NEWMAR CORPORATION

Date: June, 14, 2013
Re: Newmar Corporation – Motor Vehicle Recall Notification

Subject: Recall Campaign No.: 13V-169

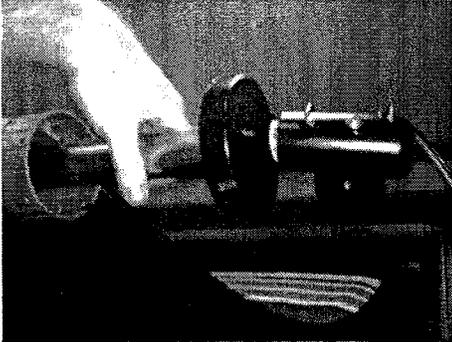
- 12) Pull out the motor/drive assembly. It should have clear plastic shrink wrap around the motor.

- 13) Install the new motor/drive assembly as follows: a) Note the location of the part with threaded screw hole that fits into the top of the arm. It should be up and down (parallel to right arm). If the part is not aligned properly rotate the motor until it is in position, then b) Slide motor into tube taking care to fold the plastic cord back into the notch in the groove as you push the motor in. Please do not cut this cord. It secures the fabric on the roller to keep it from shifting. c) Place end of awning back into top of arm. Align slot in end of awning into groove in arm.
